TECHNICAL SERVICE BULLETIN

1" Automatic Diesel Nozzle Thread Leaks

Figure 1

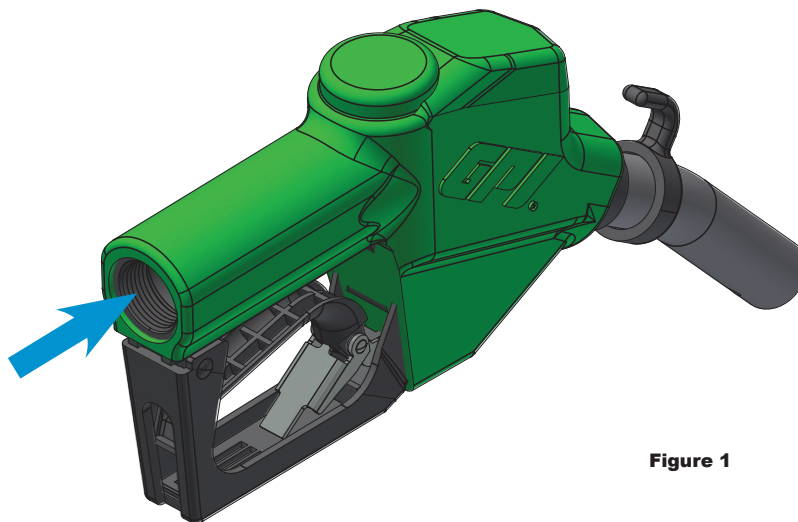
Intermittent tolerance variance on inlet thread of nozzle may result in leaking at hose connection when the nozzle is installed without the use of a pipe thread sealant paste. Nozzles reported with this issue have been evaluated by GPI. The threads of the nozzles were checked with gauges, and it was discovered that we had received nozzles with BSPT threads from our supplier.

GPI has adjusted the tolerance specifications of the nozzle inlet port (see Figure 1) to improve thread engagement with hose end fittings at this connection point.
